Rezoning Transportation Analysis
Petition Number: Insert Zoning Petition #2020-190
General Location Identifier: Tax ID 12522705

Revision Log:	Date	Description
	01-21-21	First Review (WB)
	02-15-21	Second Review (WB)

Transportation Summary

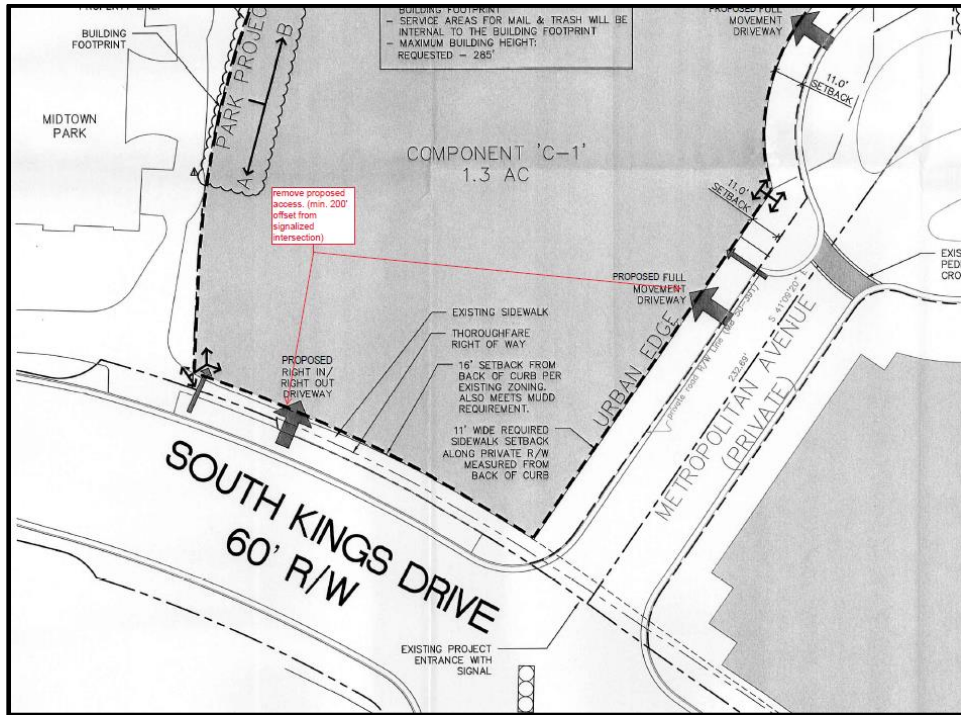
Provide comments to the specified comments below.

1. ~~**Curblin**~~: The proposed zoning district has a setback measured from back of the existing or proposed future curblin.
 - a. ~~**Kings Drive**~~: The future location of curb and gutter is in its existing location.

Label and dimension the curb and gutter from the centerline for each road on the site plan.
2. **Traffic Study: (Choose One)**
A Traffic Impact Study (TIS) is not necessary for the complete review of this petition due to the site generating less than 2,500 daily trips. If during the permitting process the site generates more than 2,500 daily trips, then a traffic study will be required.
3. ~~Revise site plan and conditional note(s) to commit to dedicate 40' right-of-way from the South Kings Drive centerline. The site plan shall label and dimension the right-of-way from the road centerline.~~
4. Revise site plan to remove proposed driveways shown within the 200' minimum required offset from a signalized intersection in accordance with the City of Charlotte Driveway Regulations (Chapter 4, page 19).
